# Corn Street, Old Reynella

## Road Safety Audit

April 2016

Figure 7 – Example of a steeper island, almost double the height of that shown in Figure 6.

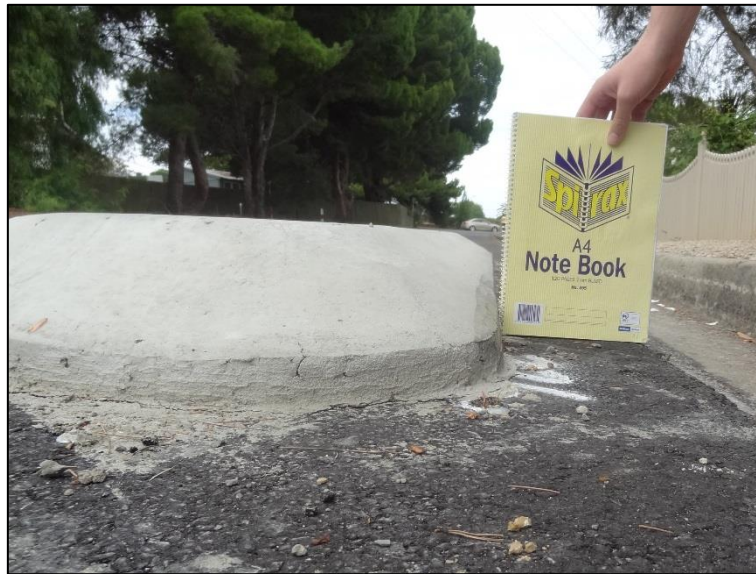
- c) The height of the concrete islands throughout the scheme is inconsistent. Some of the islands are of sufficient height and edge gradient that would enable a light vehicle to mount the island, while others are higher and have steeper edge gradients. The key concern is that when driving, it can be difficult for the driver to judge the height. If the driver was to mount a lower island, there may be a misconception that all islands are easily mountable, resulting in a risk of loss of control of the vehicle when attempting to mount a higher island as steering may be deflected.

**Figure 6 – Example of a shallower island, almost half the height of that shown in Figure 7.**
